Docket Item #6 & #7 BAR
CASE # 2016-0425 &
2016-0426

BAR Meeting
January 18, 2017

ISSUE: Partial Demolition and Alterations

LOCATION: 724 South Fairfax Street

Figure 2: Elevations not visible from public way

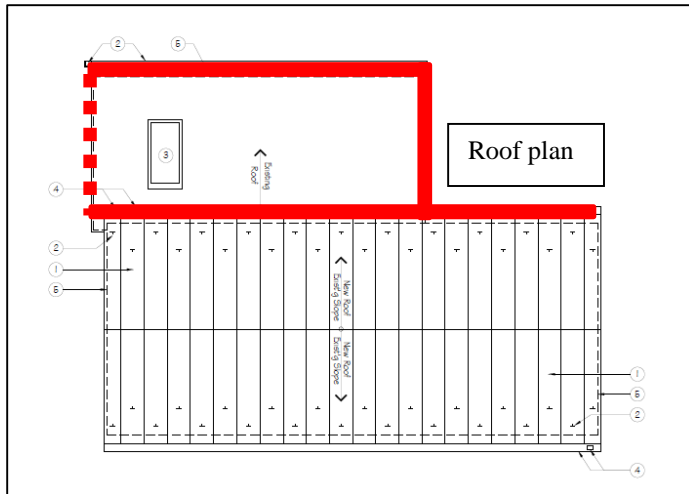
While staff routinely approves replacement materials administratively on historic buildings when the new materials are historically appropriate and comply with the BAR's adopted policies, the applicant proposes to use synthetic materials which require the approval of the Board. Although approval of some of the proposed alterations to 724 South Fairfax could have been achieved through the administrative approval process, they are included here so that the Board can see the comprehensive alterations proposed by the applicant and to reduce the application fees. The Board's approval authority is limited to the front and side elevations of the main block of the house because staff has determined that the other elevations of the house are not visible from the public way (figure 2). Although the north elevation of the one-story rear addition is partially visible (dashed line in figure two), it is only minimally visible and of later construction, so staff can support the use of synthetic materials on this elevation.

D3

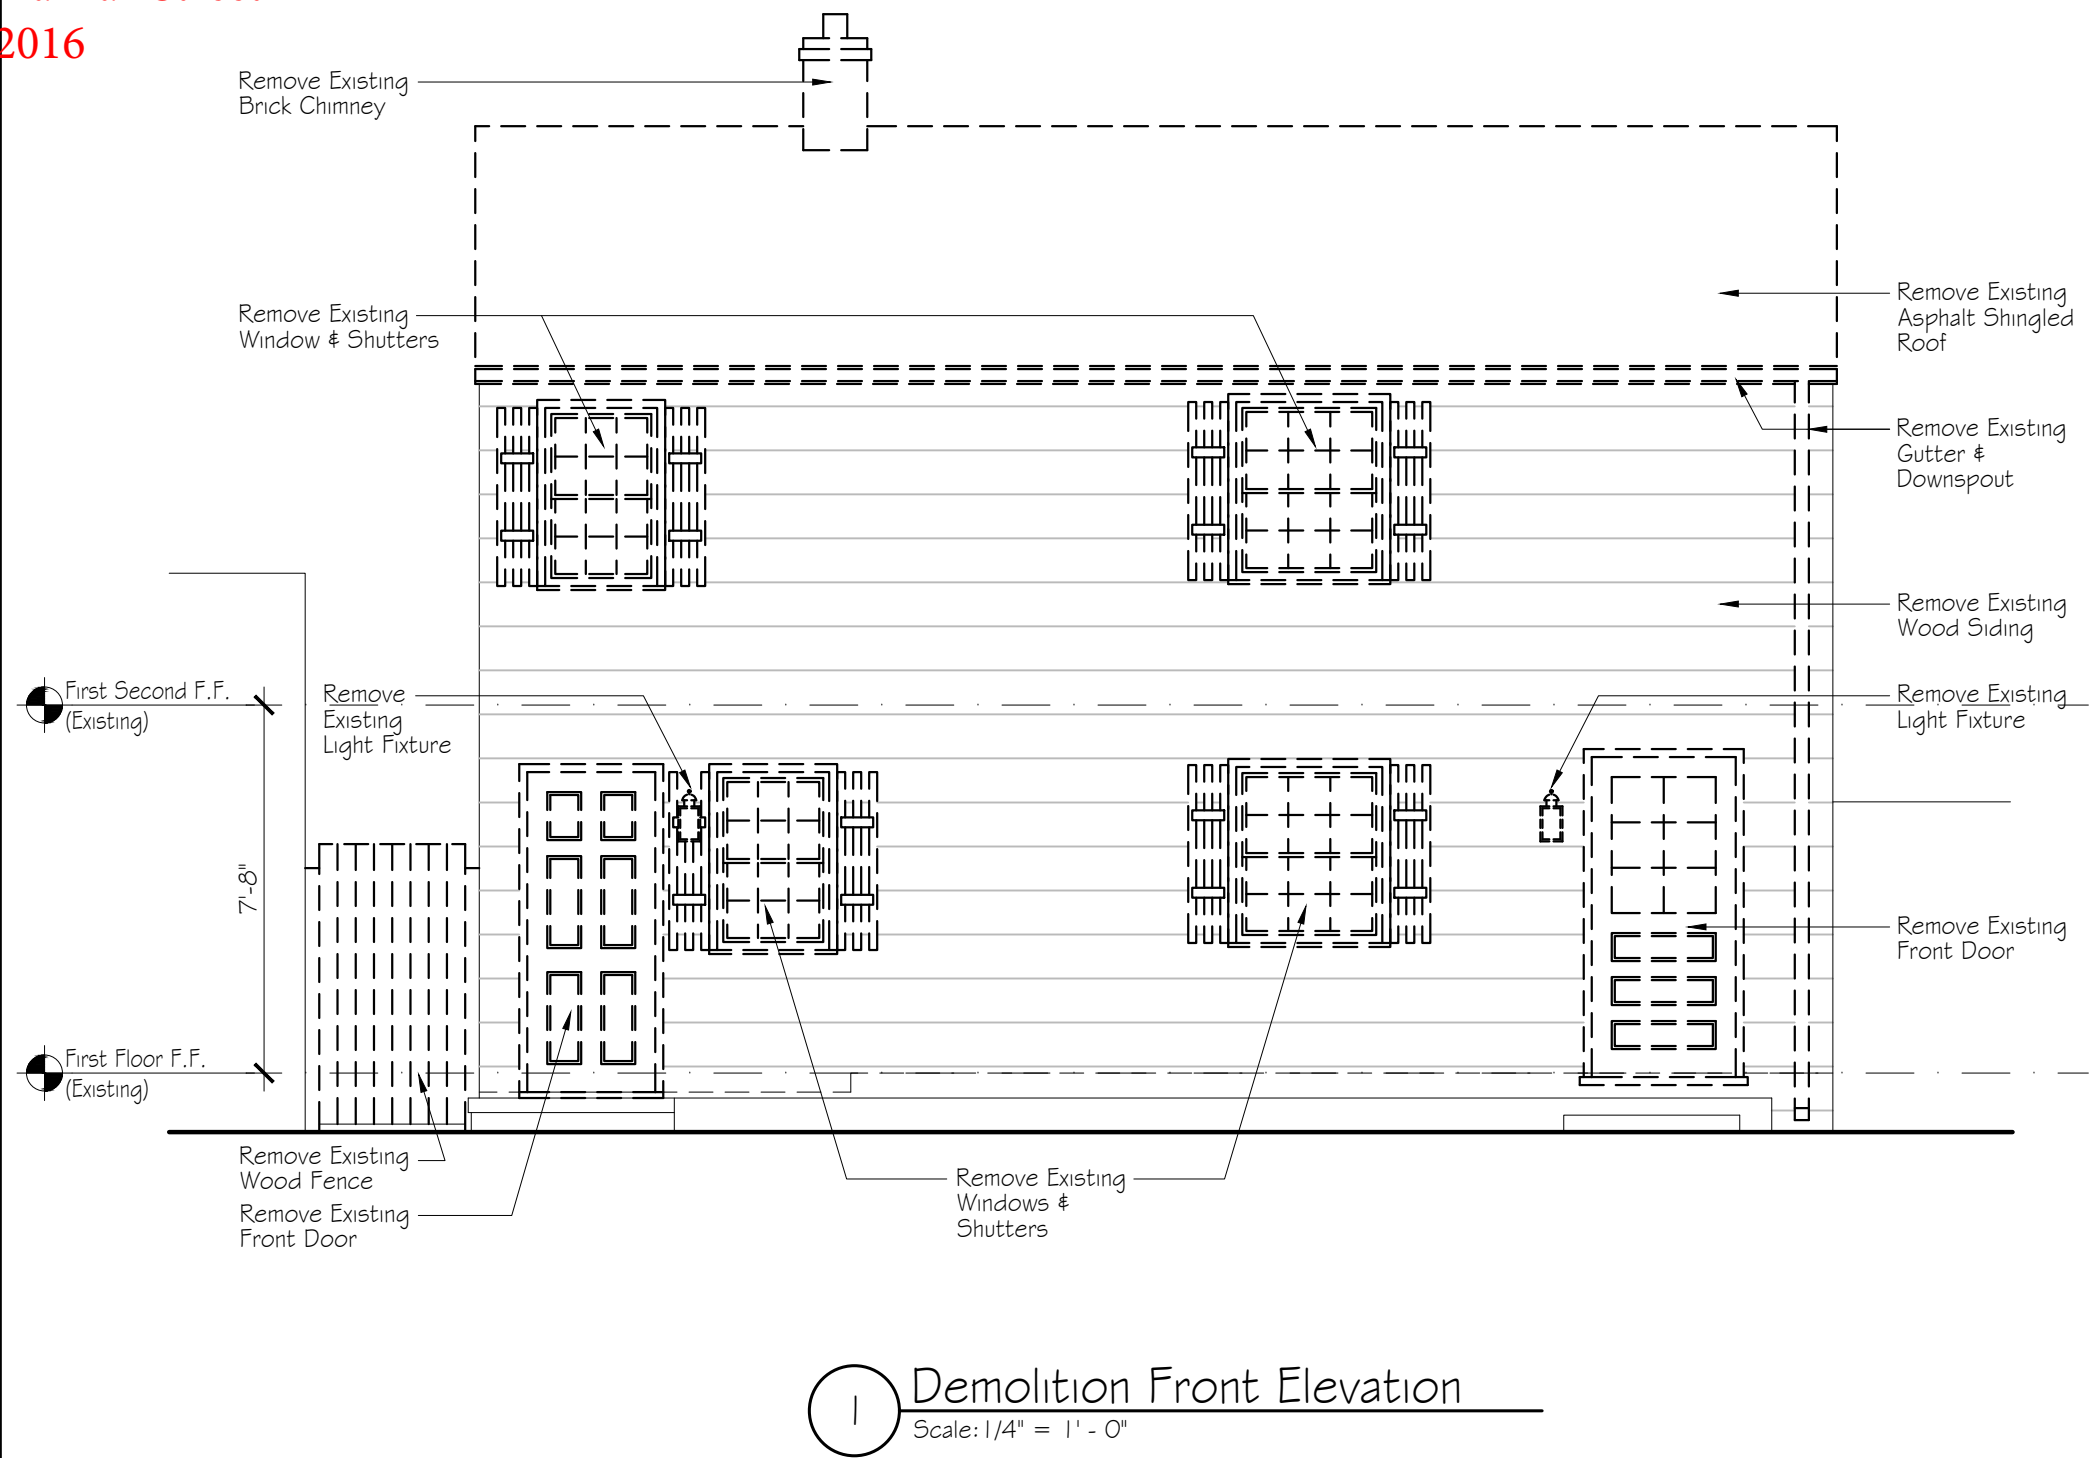
- Demolition of the brick chimney flue.

While chimneys are considered one of the character defining features of early houses, the extant chimney (Figure 1), with its hard fired brick and Portland cement mortar, does not appear to date to the building's original period of construction. In the opinion of staff, the current chimney's demolition will not remove any portion of the building containing character-defining features of uncommon design or cultural or architectural merit and will not compromise the integrity of the building as a whole. Therefore, staff recommends approval of the Permit to Demolish.

Staff recommends **approval** of a Permit to Demolish to demolish the existing chimney, and a Certificate of Appropriateness for the following new materials:

Proposed Front Elevation

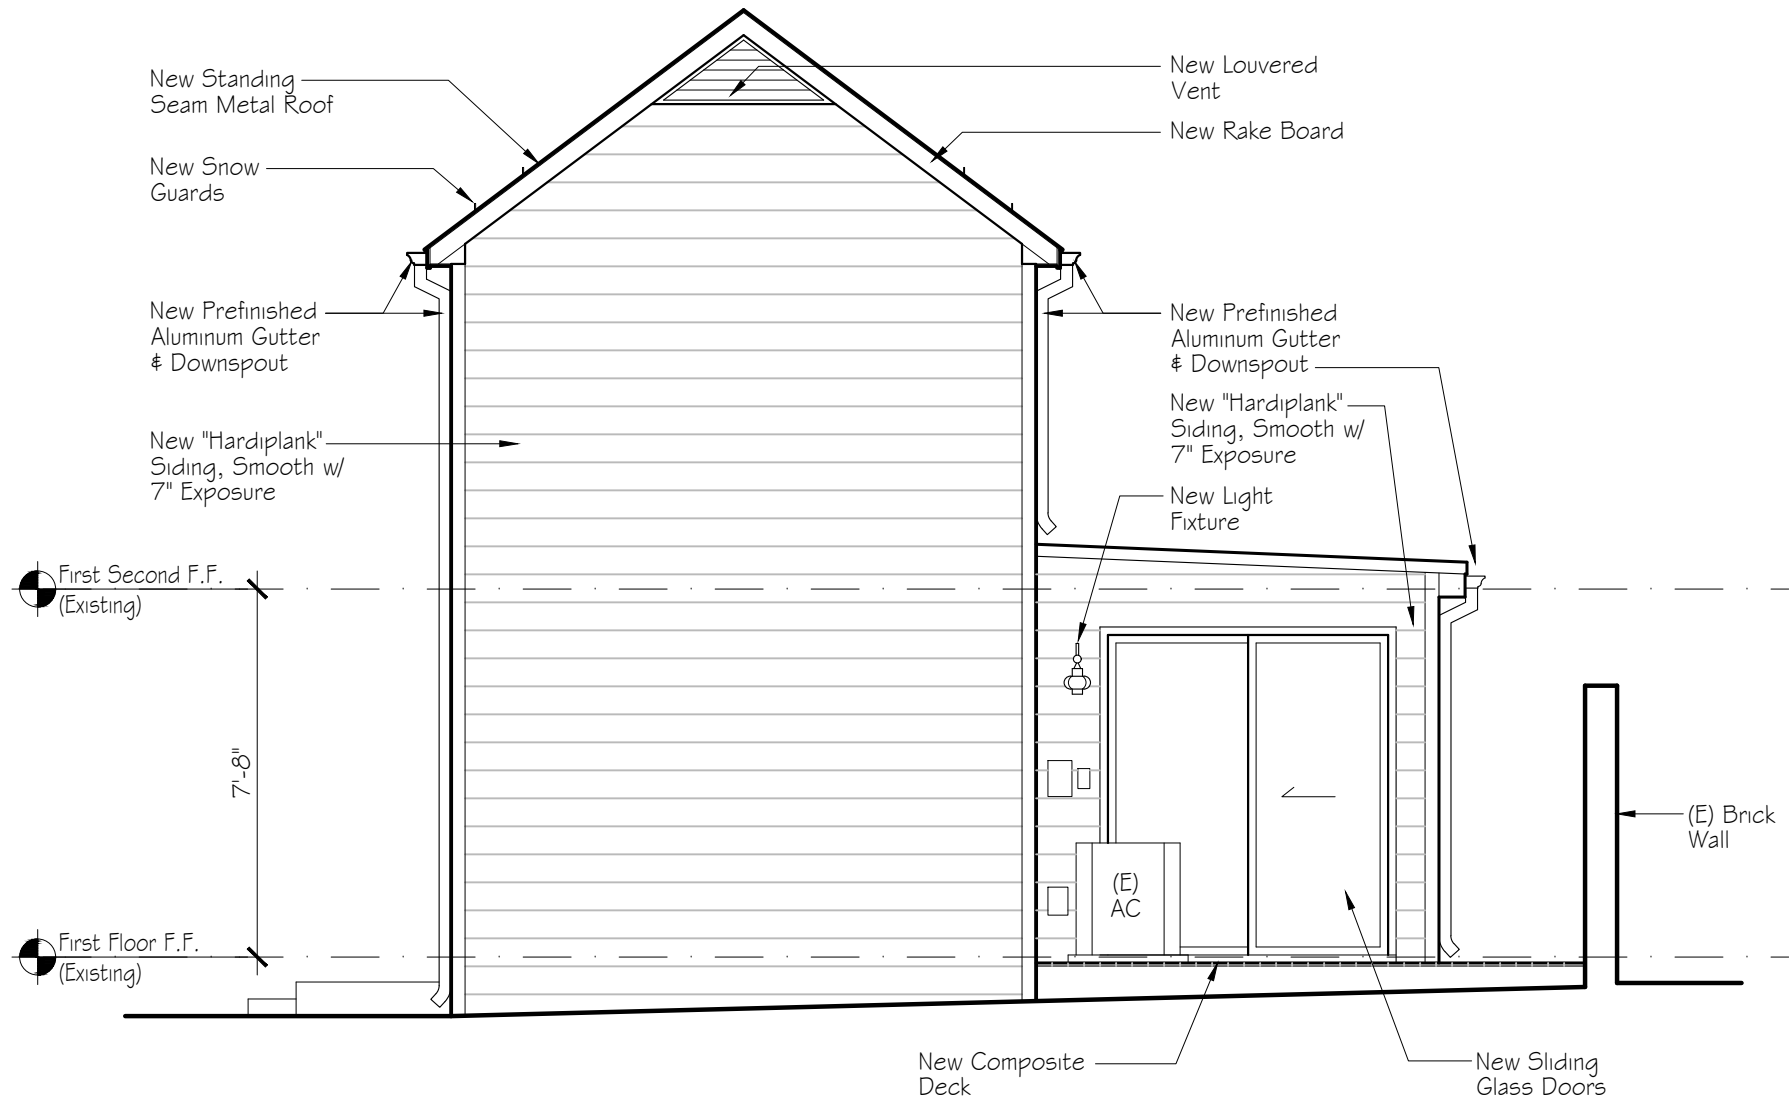
However, staff does not support the use of HardiePlank synthetic siding or aluminum clad windows on the main building block. Although modest in scale and design, the subject property contributes to the evolving streetscape of the southern quadrant of Old Town, and the use of historically appropriate materials on the main block, which is located on the front property line where the materials are subject to close inspection, is essential to retaining the integrity of this early building.

For these reasons, staff recommends that the Board deny the use of aluminum clad windows on the front façade of the main block, and instead approve painted wood windows, with single-glazed windows on the street-facing façade (these may have either a removable double glazing panel or storm windows) and simulated-divided-light painted *wood* windows on the visible secondary elevations. The replacement windows must also meet the *Alexandria Replacement Window Performance Specifications*. The windows and siding on non-visible elevations may be any material permitted by the building code.

1. HardiePlank siding on the three visible elevations of the historic main block and *approval* of historically appropriate wood siding, provided that staff confirms in the field that historic wood siding does not exist below the existing asbestos siding; and,
2. Aluminum clad windows on the front facade of the historic main block and *approval* of painted wood, true-divided-light wood windows on the front façade and wood, simulated-divided-light wood windows on the north side elevation.
